CONSTRUCTION PLANS FOR HIGHPOINT OAKS ESTATES

CITY OF LEWISVILLE DENTON COUNTY, TEXAS

PRELIMINARY FOR REVIEW ONLY
 NOT FOR CONSTRUCTION OR PERMIT PURPOSES

STORM SEWER PLAN & PROFILES
 LINE-A, A3 & EX-1
 HIGHPOINT OAKS ESTATES
 City of Lewisville, Denton County, Texas

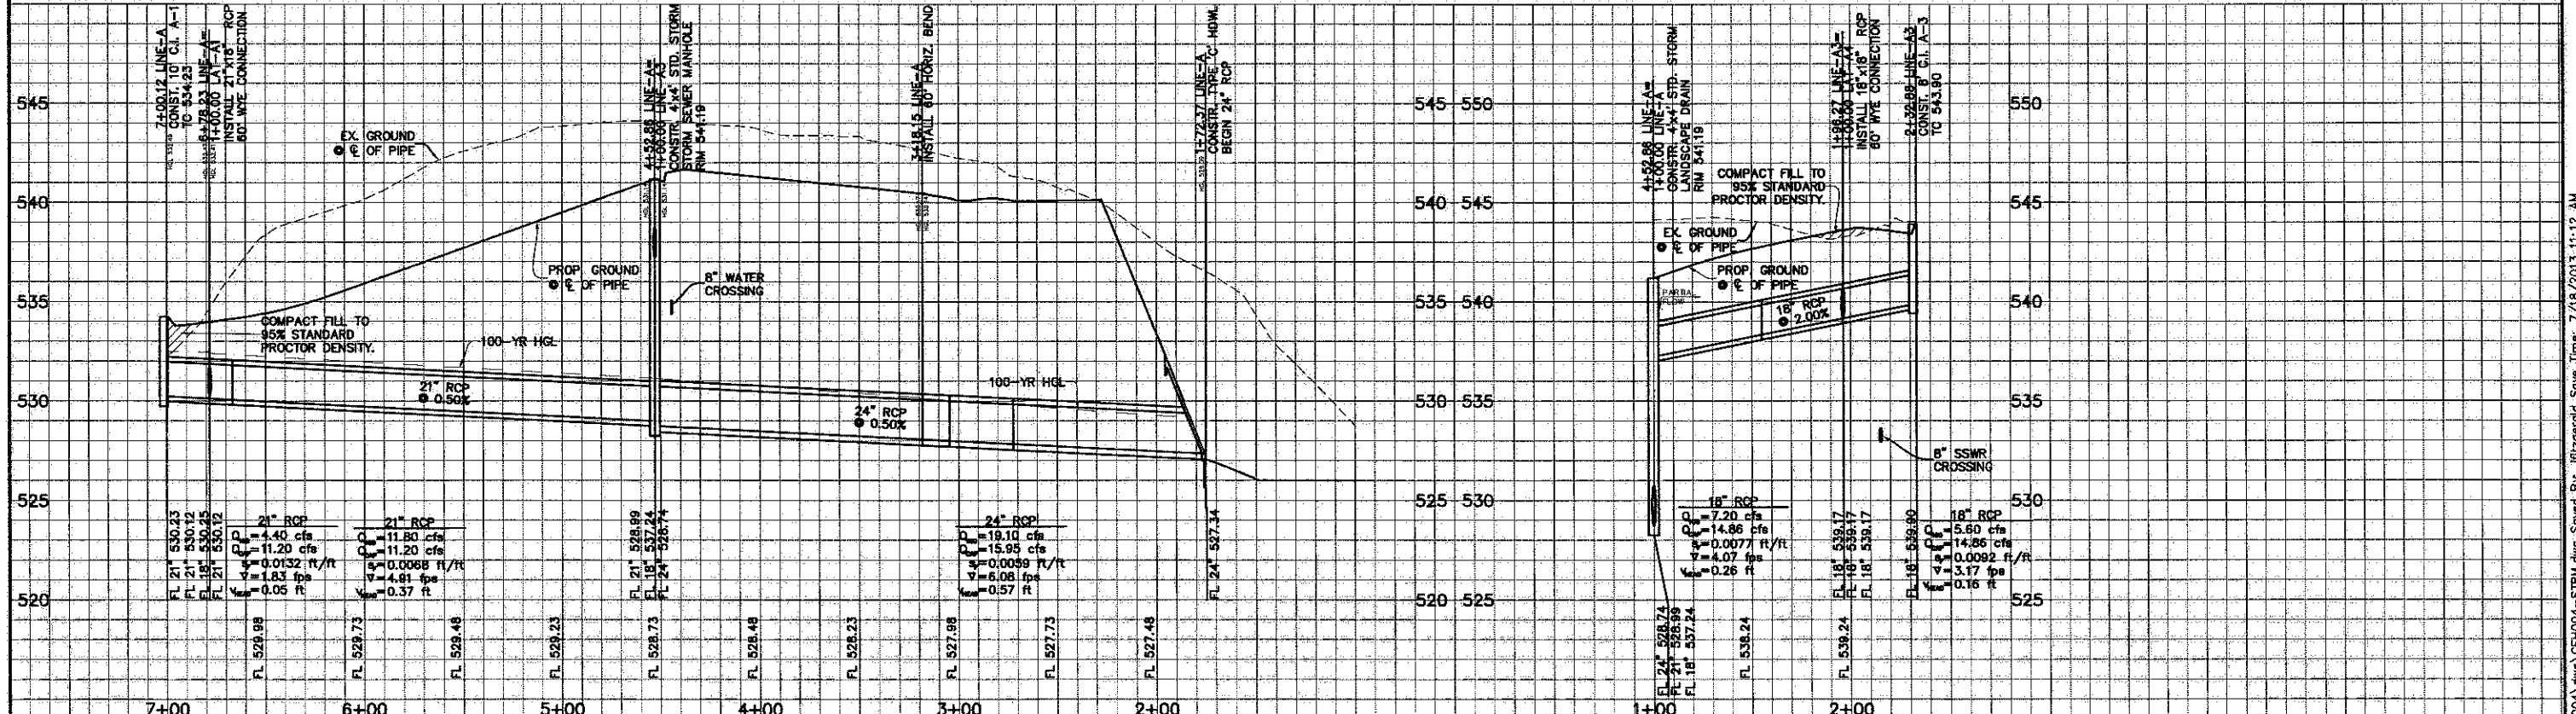
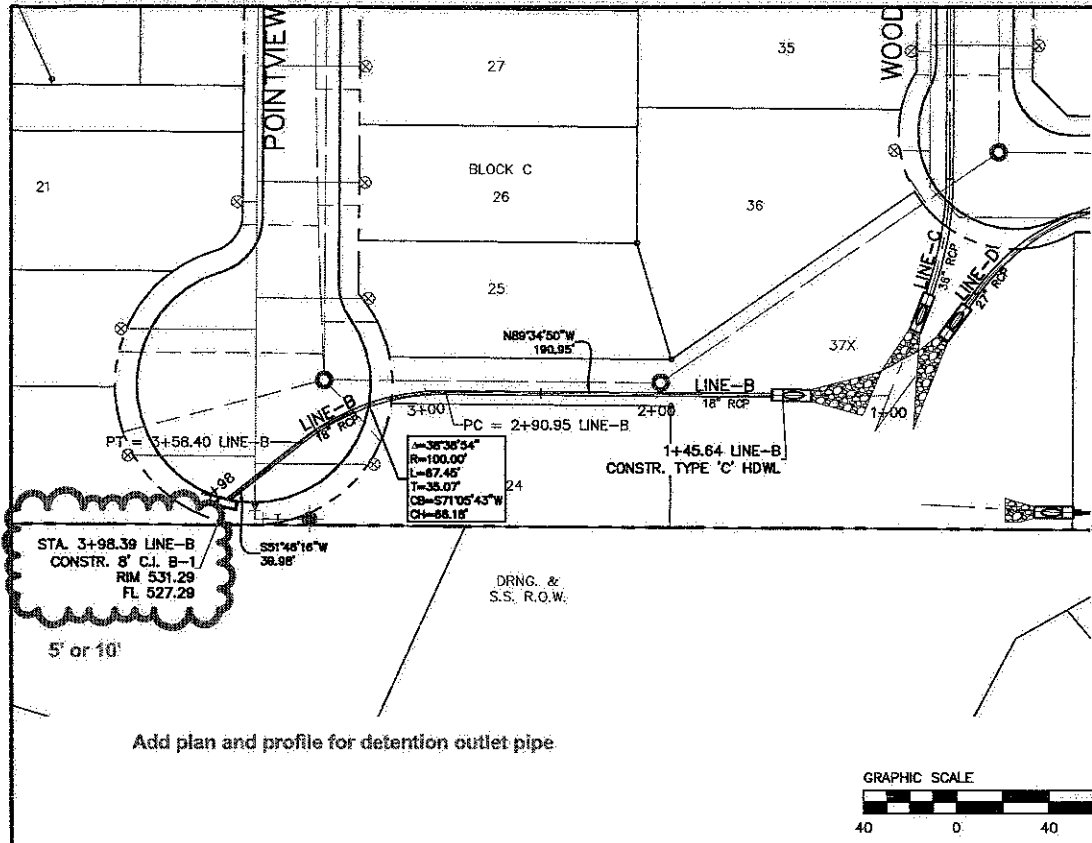
Add plan and profile for detention outlet pipe
